MEMORANDUM FOR THE RECORD
APPLICATION# 22 IWC 25
REGULAR MEETING – THURSDAY, NOVEMBER 17, 2022

Prepared by Meredith Badalucca, Zoning & Wetlands Officer

Applicant: John M. & Lynette S. Crowley
Property Owner: John M. & Lynette S. Crowley
Engineer: DLC Engineering Services, LLC
Address: 137 Gay Hill Road (M/B/L 023-026-00A), Uncasville, CT
Submitted: November 7, 2022
Date Received by IWC: November 17, 2022 (DRD 1/21/23)

Applicant Requests: The applicant is requesting a favorable recommendation/report from the Commission to the Planning & Zoning Commission for a 2-Lot re-subdivision with no regulated activities in accordance with CT General Statutes (CGS) Section 8-26 (Applications involving an inland wetland or watercourse) and as required by Section 3.4.2 of the Montville Subdivision regulations.

137 GAY HILL ROAD SUBDIVISION
PROPERTY BELONGING TO:
JOHN M. & LYNETTE S. CROWLEY
137 GAY HILL ROAD
MONTVILLE, CONNECTICUT
ZONE: R-40
SCALE: 1" = 40'

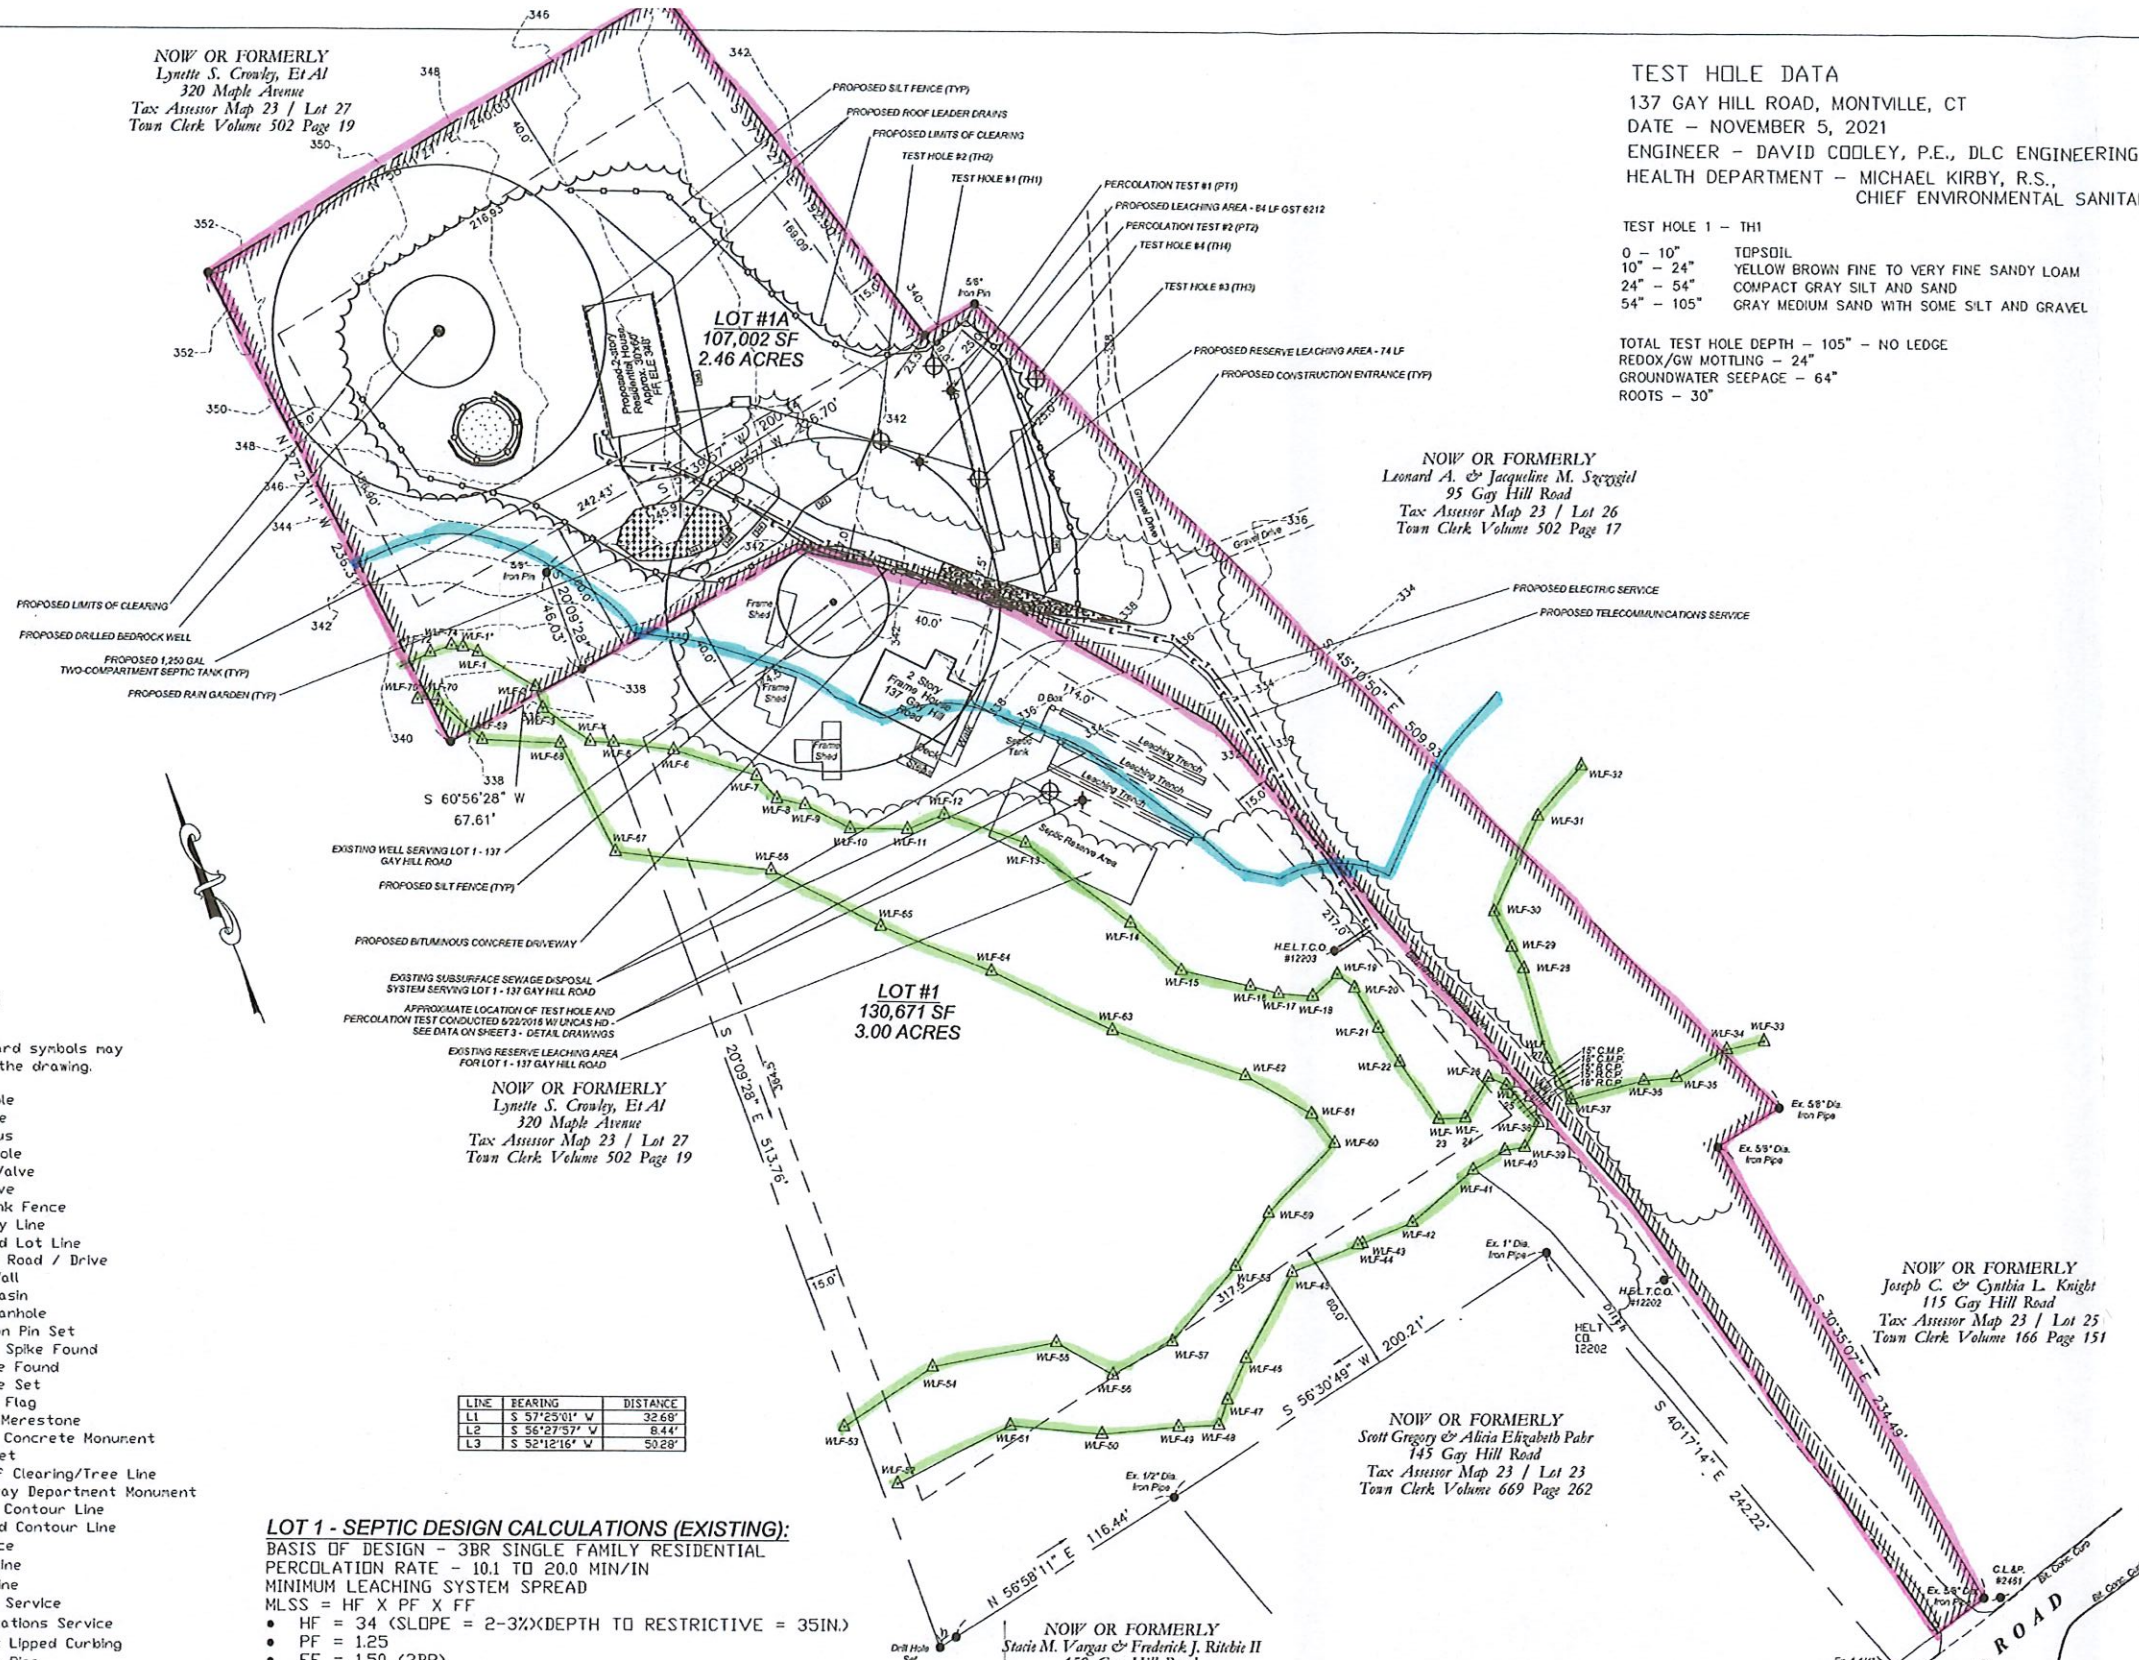
- There is no regulated upland or wetlands activity proposed as part of this development.
- The property to be subdivided is shown on a plan entitled “Property Survey, Property Belonging to: 137 Gay Hill Road Subdivision, John M. & Lynette S. Crowley, 137 Gay Hill Road, Montville, Connecticut, Zone: R-40, Scale: 1’ = 40’, Revised August 15, 2022”
